Service Bulletin

Number: A6-87-17

SL-P1200
Compact Disc Player

Number: A6-88-11

FIGURE 1 - PCB LAYOUT (TRANSISTORS LOCATION)

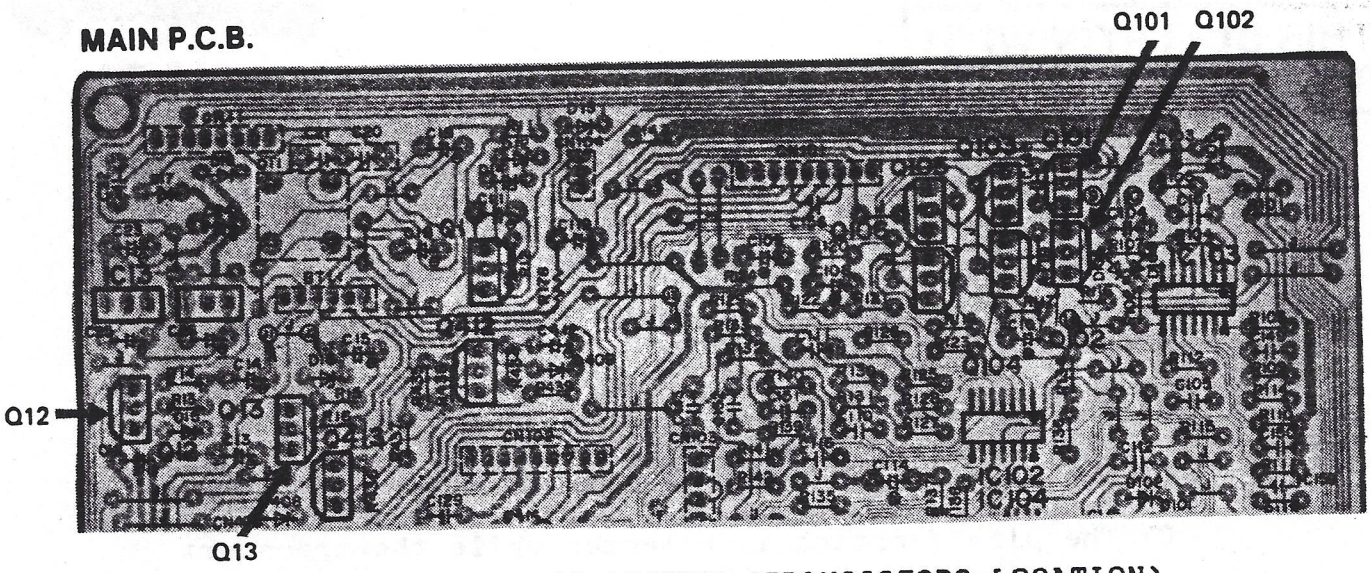
Each of the above conditions cause Q12, Q13, Q101, and Q102 to overheat and become damaged. The excessive heat causes the transistor's solder joints to dry and therefore cause poor connection, or solder bridges.

Remedy: 1) Order kit number SZZP1093C. Refer to the kit contents below.
2) Replace the transistors as indicated in Figure 1.
3) Mount the heat sink to IC501 as shown and indicated in Figure 2.

DESCRIPTION	REF. NO	ORIGINAL PART NO.	NEW PART NO.	KIT PART NO.
TRANSISTOR	Q12	2SC1846 OR 2SD973	2SD1266	SZZP1093C
TRANSISTOR	Q13	2SA885 OR 2SB793	2SB941	
TRANSISTOR	Q101	2SD1055	2SD1266	
TRANSISTOR	Q102	2SB822	2SB941	
HEAT SINK	----	----------	SMWD3E

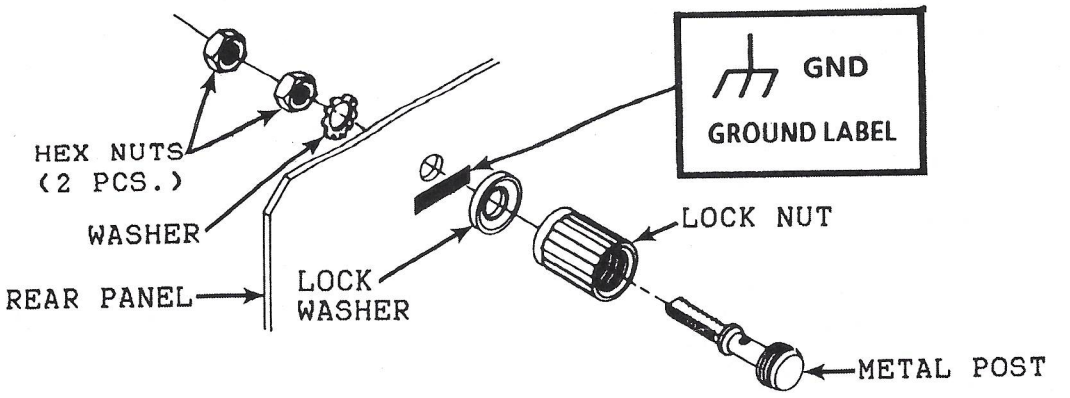
1) Mount a ground lug according to the following:
   A. Drill a 4mm hole on the indicated location of the rear panel. Make sure that no filings fall inside the unit.

B. Mount the ground lug as follows:

C. Affix the "GND" label below the ground lug.

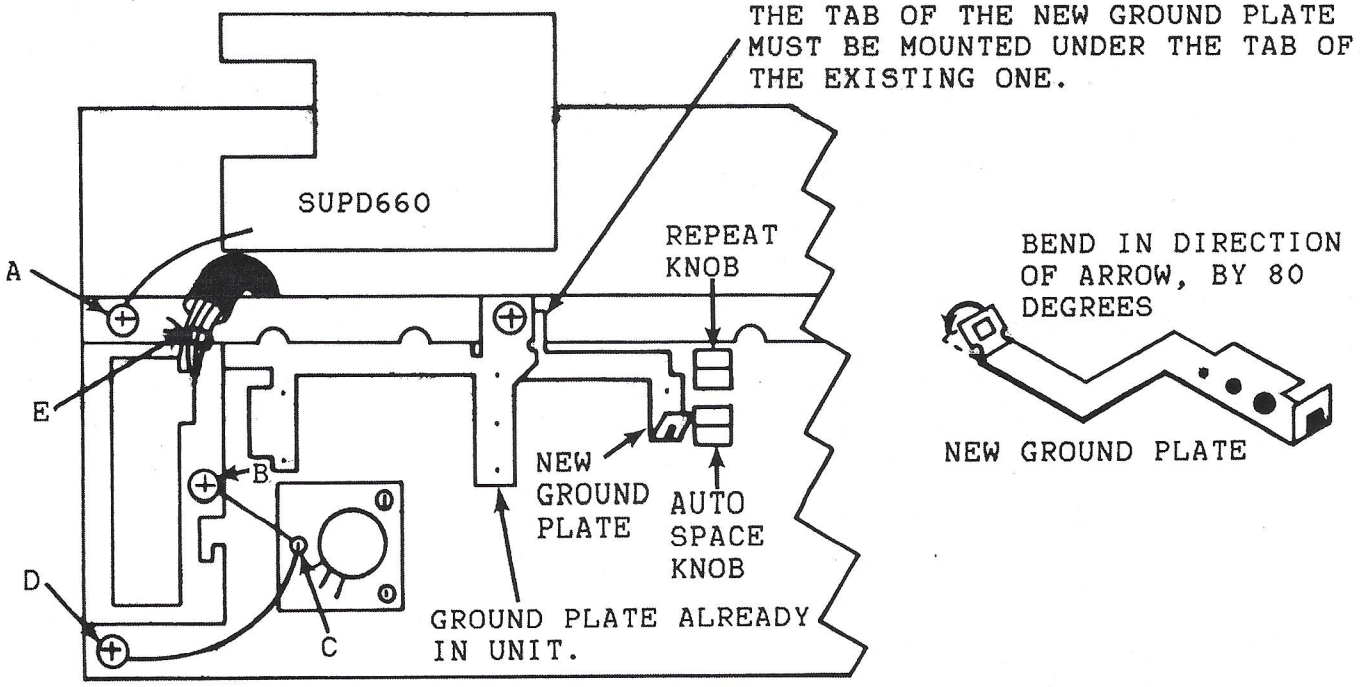
2) Modify the front panel grounding as follows, and as shown in the figure below:

A. Remove the operation PCB (KEYBOARD PCB) according to the Service Manual, page 17.
B. Cut the wire tie at point "E".
C. Remove the ground wire from points "A" and "B". Mount this wire between points "C" and "D". Use the screw (included in the kit) to mount the wire at point "D".
D. Tie the wires at point "E" by using the wire tie.
E. Remove the REPEAT and AUTO SPACE knobs.
F. Mount the new ground plate.
G. Mount the REPEAT and AUTO SPACE knobs.

SWITCH TERMINAL MODIFICATION

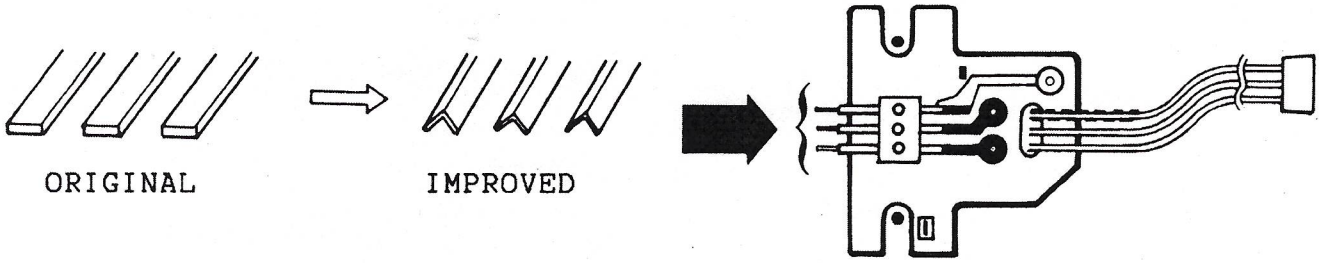
B. Check the OPEN/CLOSE detection switch S101. Make sure that all three terminals make good contact. If poor contact is noticed, replace it with the switch assembly (Part Number SWSD12001). See figure below:

SWITCH ASSEMBLY - SWSD12001
